**New Albany Planning Commission
March 4, 2024 Informal Meeting Minutes - Approved**

**COURTYARDS AT HAINES CREEK SUBDIVISION
FINAL DEVELOPMENT PLAN**

LOCATION:	Generally located at the northwest corner of the intersection at Central College Road and Jug Street Rd NW (PIDs: 222-005156, 222-005157, 222-005158, 222-005159).
APPLICANT:	EC New Vision Ohio LLC, c/o Aaron L. Underhill, Esq.
REQUEST:	Final Development Plan
ZONING:	Courtyards at Haines Creek I-PUD Zoning District
STRATEGIC PLAN:	Residential District
APPLICATION:	FDP-87-2023

This application is for a final development plan for a new 151 lot age-restricted subdivision known as “Courtyards at Haines Creek”. There is also a preliminary plat application for the subdivision on the agenda, which is evaluated under FPL-09-2024.

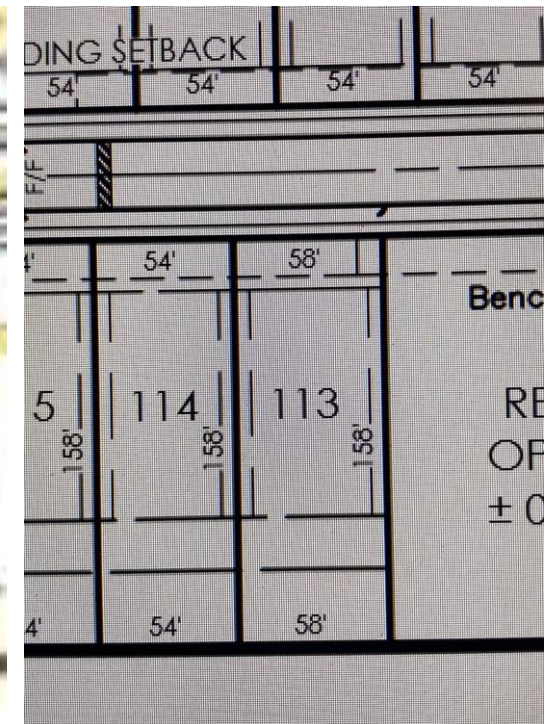
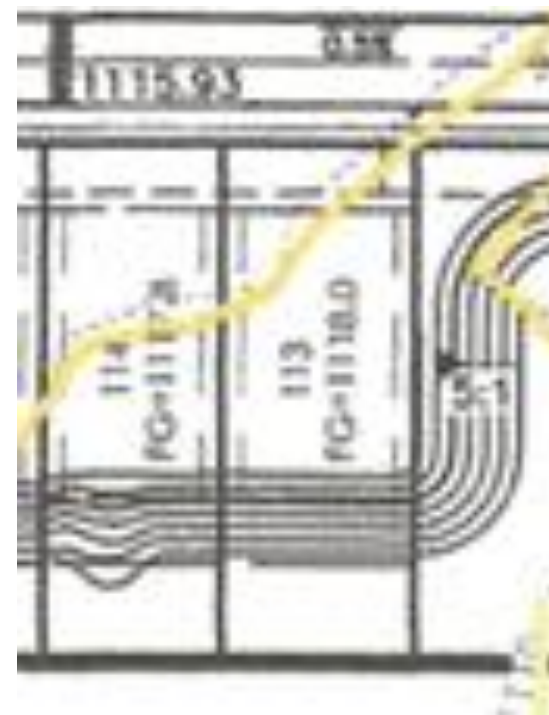
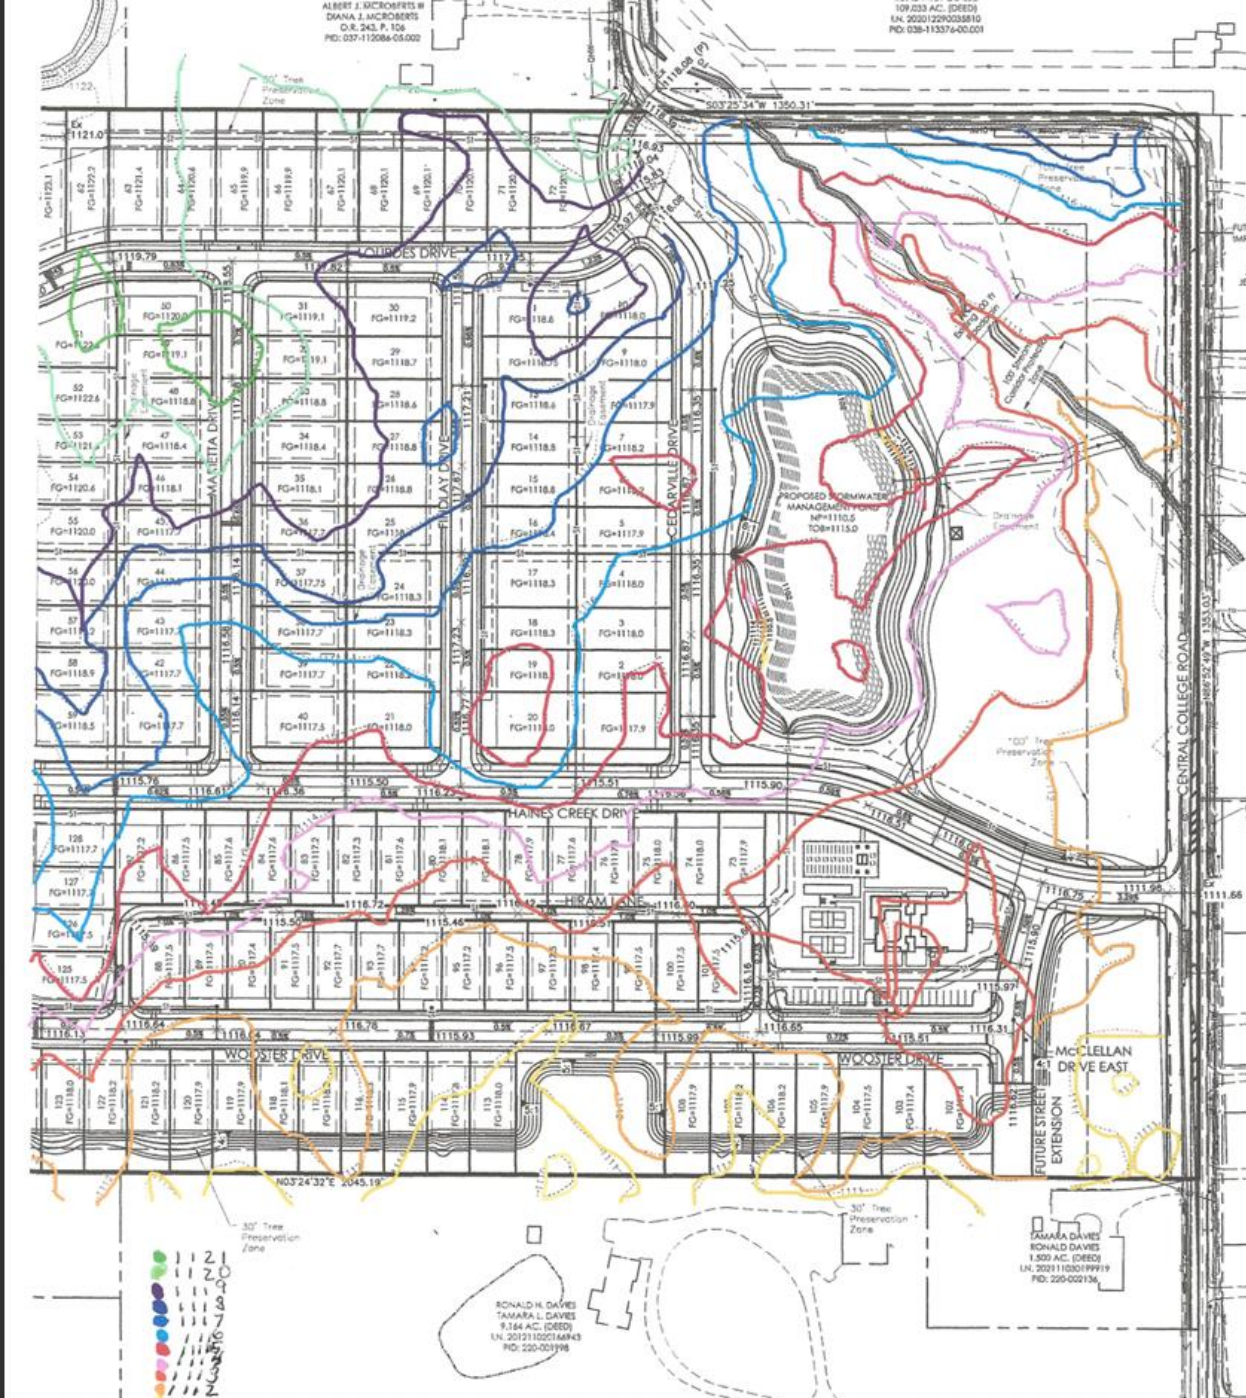
- Pending Ohio EPA approval
- Impacts acres of wetlands
- New Albany Instagram post

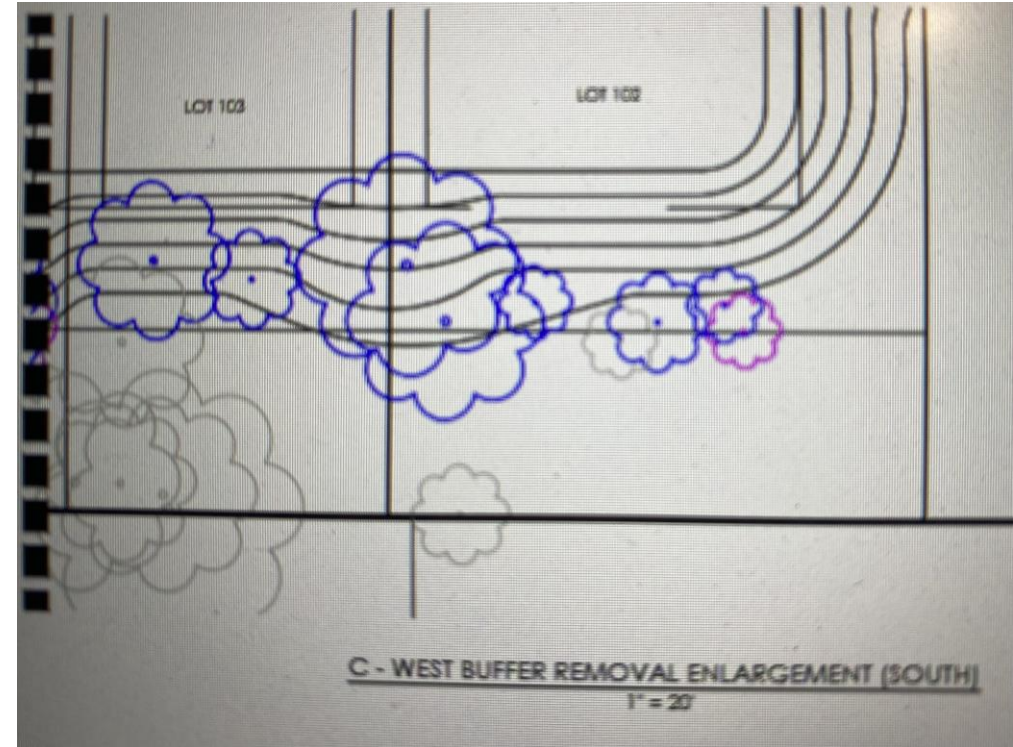
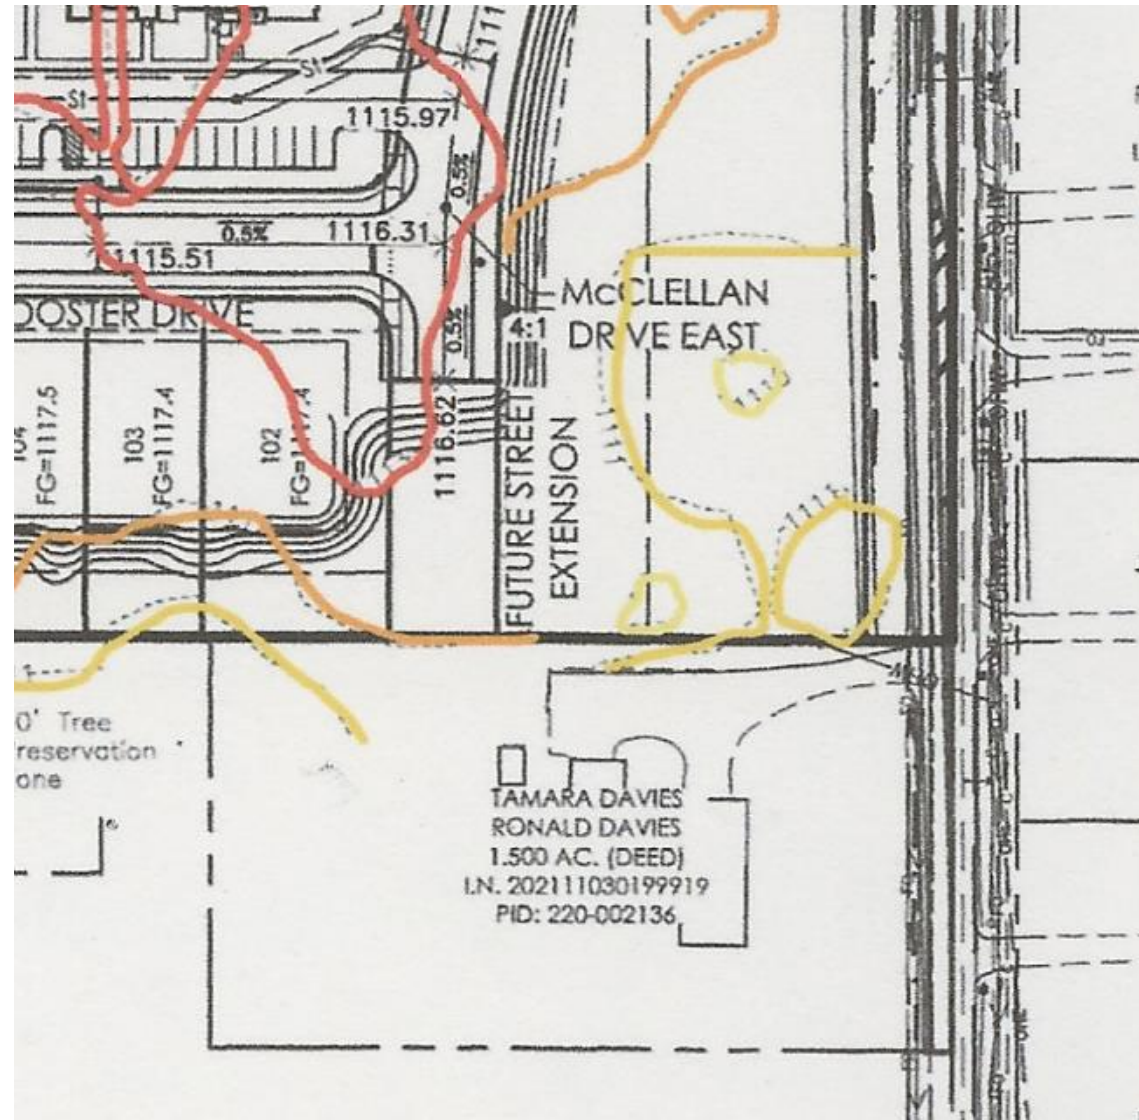
$$158' \times 58' = 9164 \text{ft}^2$$
$$1118-1110=8\text{ft}$$
$$9164\text{ft}^2 \times 8\text{ft} = 73312\text{ft}^3 \text{ or } 2715 \text{ cubic yards}$$

Dump truck load = 10 to 14 cubic yards

Therefore lot #113 will need 194 to 272 dump trucks full of dirt.

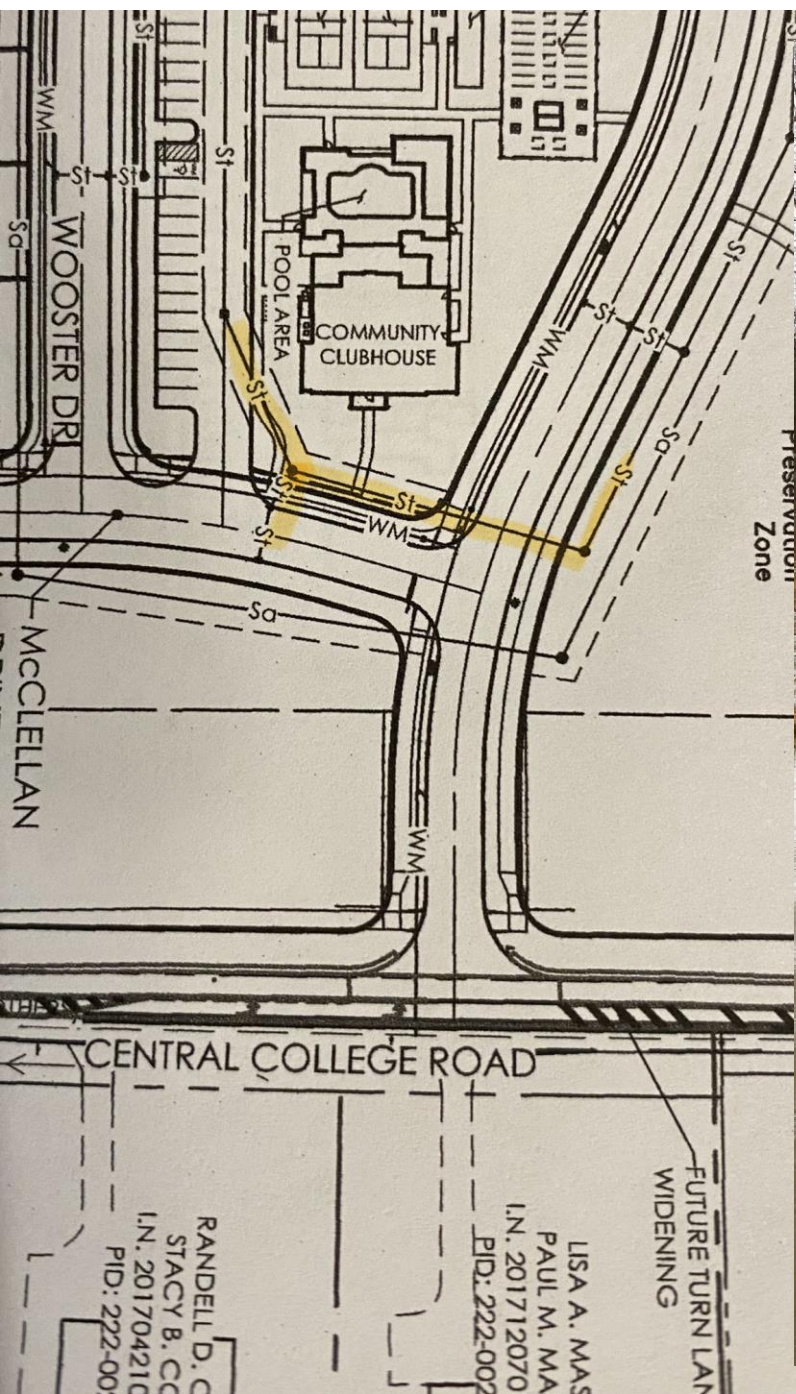
The home on lot# 102 will be 7 feet higher than the home at 8238 Central College Rd

The road stub will be 7 feet above grade for our home at 8238 Central College Rd. This disparity negatively effects the home's value.

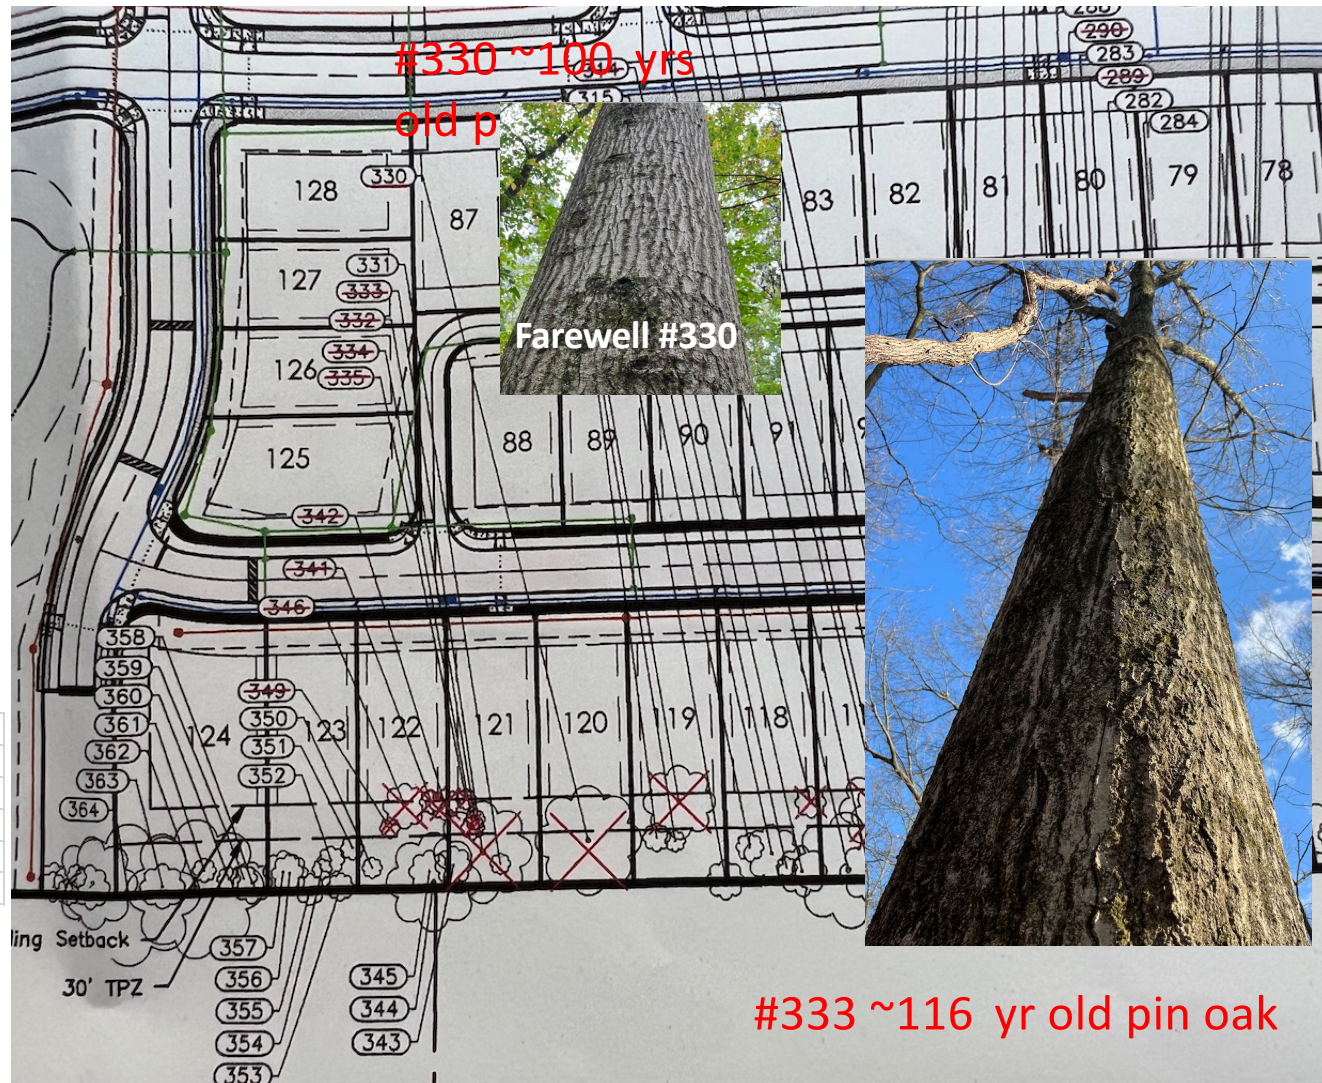
- Why is the city allowing the removal of 330 & 333?
- Both in tree protection zone
- Both in good condition (per Arborist)
- ~93 & 116 yrs old

Survey #		Trunk size		Age
175	Pin Oak	6	Poor	18
194	Pin Oak	12	Fair	36
221	Silver Maple	17, 15, 11, 11, 9	Good	51
330	Pin Oak	31	Good	93
333	Red Oak	29	Good	116

Right of Way (RoW) usage

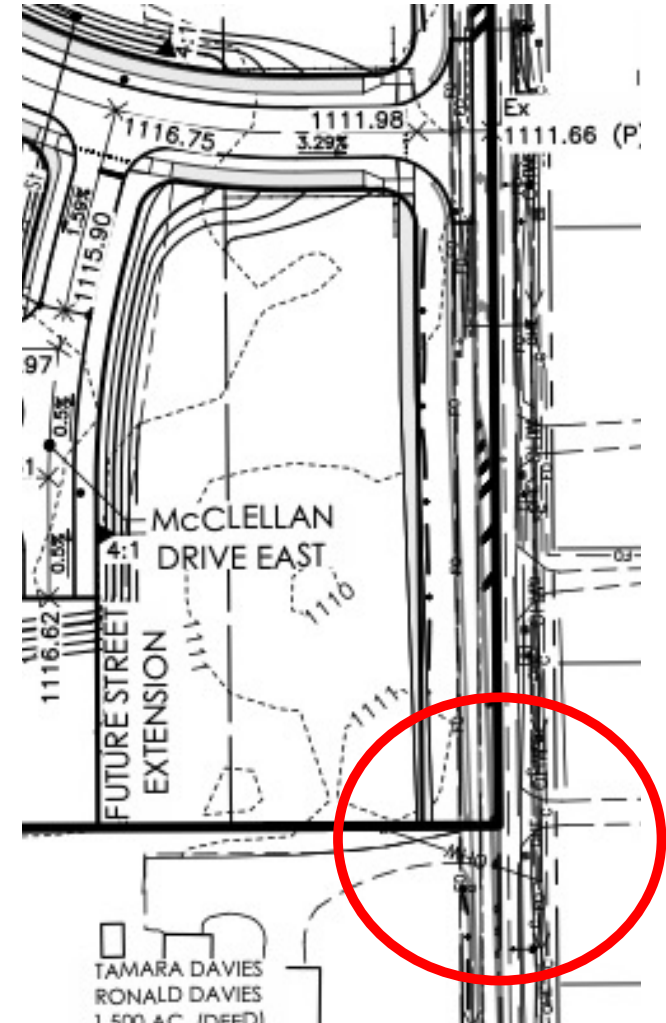
- As applicant notes –
 - “no improvements are necessary to the existing roadway”
 - “An Eastbound left turn lane....is warranted...2034”.
- Yet the City seems to ignore the study and is asking for a left turn lane now.
 - Has anyone studied the timing of the traffic patterns?
 - We would note our observations that traffic is east bound at 6:30 AM (morning commute) and reverse in the PM.
 - So an east bound left turn lane does nothing unless there is a high degree of east bound traffic turning into this project early in the morning. (this is in conflict with Applicant’s statement that 55+ communities generate less car trips on average.
- This requires the use of a RoW on the North side of CC that is not in New Albany.
- Could we expect a courtesy note that there may be impact on 8238 Central College’s driveway (note: 8238 is not in New Albany), the drain lines etc....?

Woodland Protections

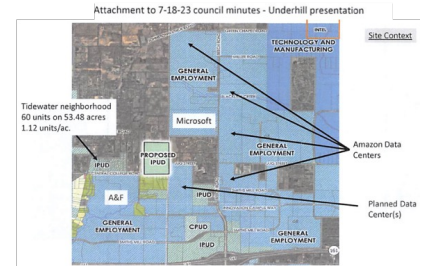
- Red Box ~11 acres
- White box – same size as red box.
- Applicant wants to clear cut majority of trees in the white box.
- Current plan does not retain substantial woodlands
